Technical Bulletin

Model: Russian-C2			Dat	e: 24-Oct-0	01	No.: RB022001
Subject: The fax			Prepared	l by: S. 1	omoe	
From: Technical	Services Dept., GTS Division					
Classification:	☐ Troubleshooting	Part info	orma	tion	Action	n required
	Mechanical	Electrica	al		Servic	e manual revision
	Paper path	🗌 Transm	it/rec	eive	Retro	fit information
	Other ()

RIGOH	Techn	ical B	ulleti	n	PAGE: 1/4
	Model: Russian-	C2		Date: 2	e-Oct-01	No.: RB022002
=	Subject: Major differences between Russian-C1 and Russian-C2				Prepared by:	S. Tomoe
	From: Technical	Services Dept., GTS Division				
	Classification:	Troubleshooting	Part inf	ormation	Action	n required
		Mechanical	Electric	al	Servic	e manual revision
		Paper path	Transm	it/receive	Retro	fit information
		⊠ Other ()

Model: Russian-C2 Da			Dat	e: 11-Jun-02	No.: RB022014
Subject: Rear Cover				Prepared by: S.	Tomoe
From: Technical Services sec. Service Planning Dept.					
Classification:	Troubleshooting Part informat		tion 🗌 Actio	on required	
	Mechanical Electrical		al	Serv	rice manual revision
Paper path Transmit		it/rec	eive 🗌 Retr	ofit information	
	Other ()

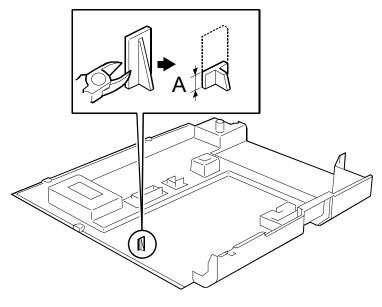
A rib on the Rear Covers produced at the factory in Korea (for machine code: B022-57) contacts the FCU bracket and prevents the cover from being installed. **Note:** Service parts are unaffected, as they are produced in Japan.

Cause

The manufacturer had used the mold for the Russian-C1 to make the Rear Cover (which normally contains the rib).

Permanent: The manufacturer will ensure that the proper molds are used for both covers.

Action in the field: When installing the optional fax unit, please cut the rib off as shown in the illustration below.

A: 0 – 3 mm
